ADDENDUM

ADDENDUM NO. 3

RE: New Bedford Marine Commerce Terminal
Phase 3 Bulkhead Replacement (Site 4)
Massachusetts Clean Energy Technology Center
Contract No. MACEC-FY26-02

E PRECAST PILE CAP SUPPORT DETAIL
SCALE: 1" = 1"
NOTES:
1) PILE PLUG REINFORCEMENT NOT SHOWN FOR CLARITY

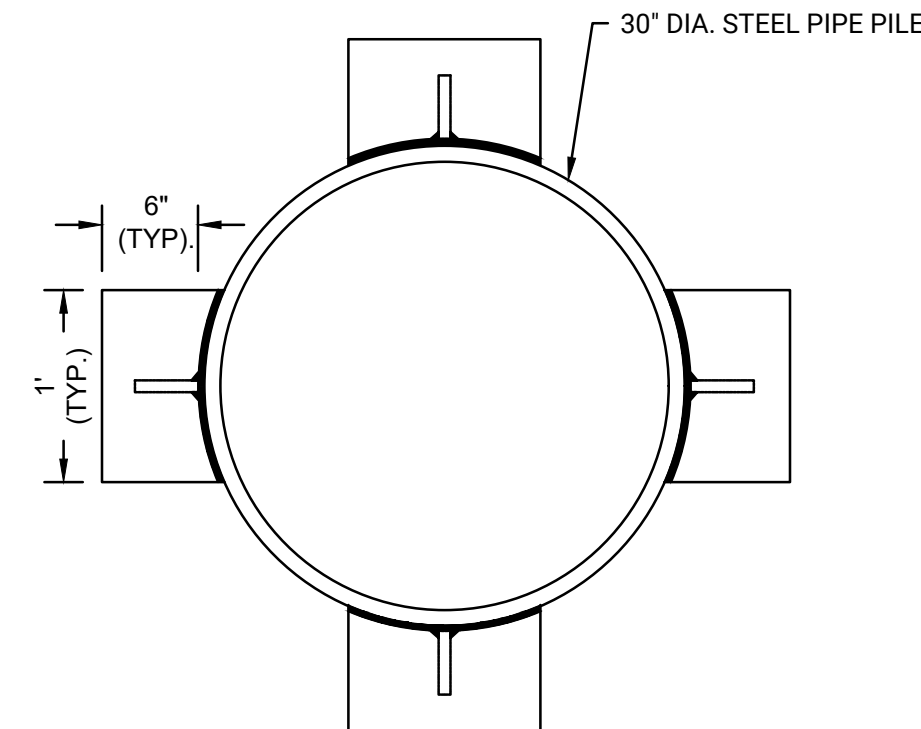
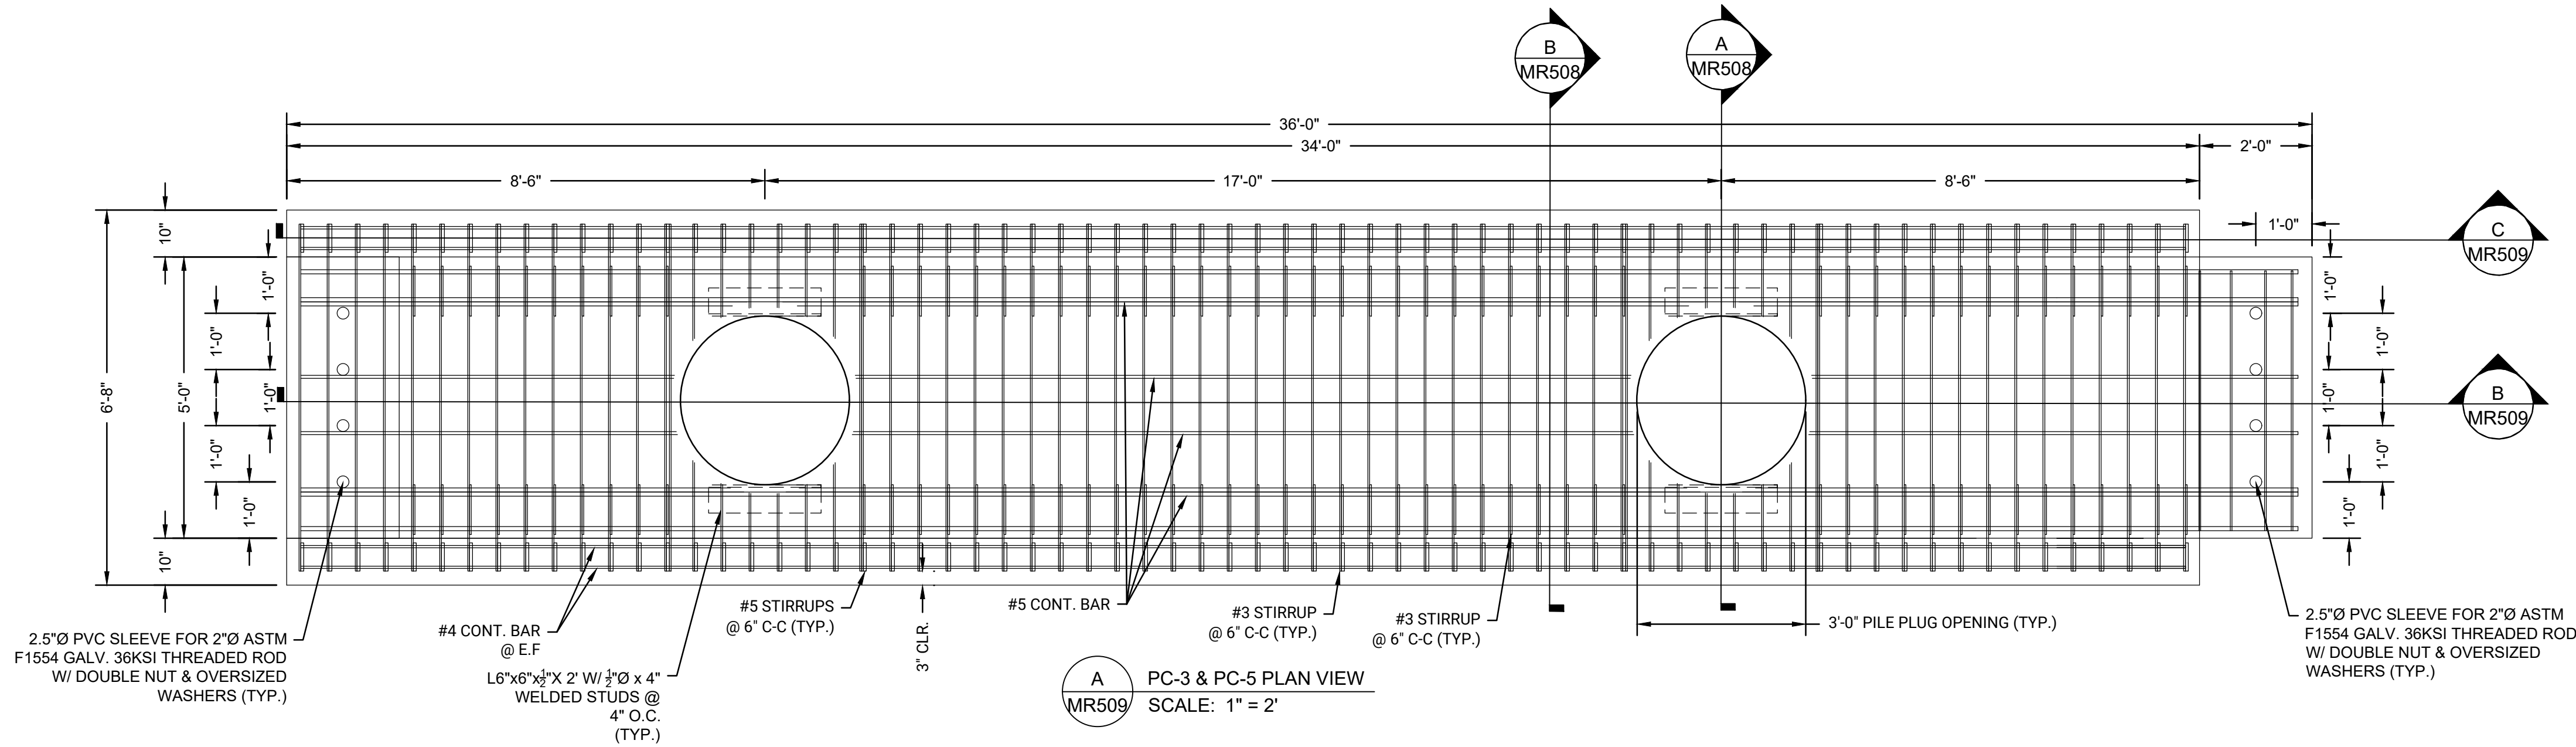
1. Drawings MR102 and MR508 through MR511 have been revised to reflect precast pile cap configuration addressing Question #2 (below). The revised Drawings are provided in **Attachment 1** to this Addendum No. 3.

1. Q: Will spiral weld pipe be acceptable?
A: YES, spiral weld pipe will be allowable steel pipe pile product.
2. Q: Are Pile Caps PC-1 to PC-8 connected to each other? If so, please provide a connections detail.
A: Please refer to the revised Drawings MR102 and MR508 through MR511, and the new Drawing MR511A. PC-1 through PC-6 have been resized and detailed to address precast pile cap connections.
3. Q: Please refer to the snapshot below from MR017. The red hatched area represents a gap between the proposed platform slab and existing Cofferdam cell which will be exposed to the open water below. Please provide a closure detail between the proposed platform slab and Cofferdam Cell to close this space.
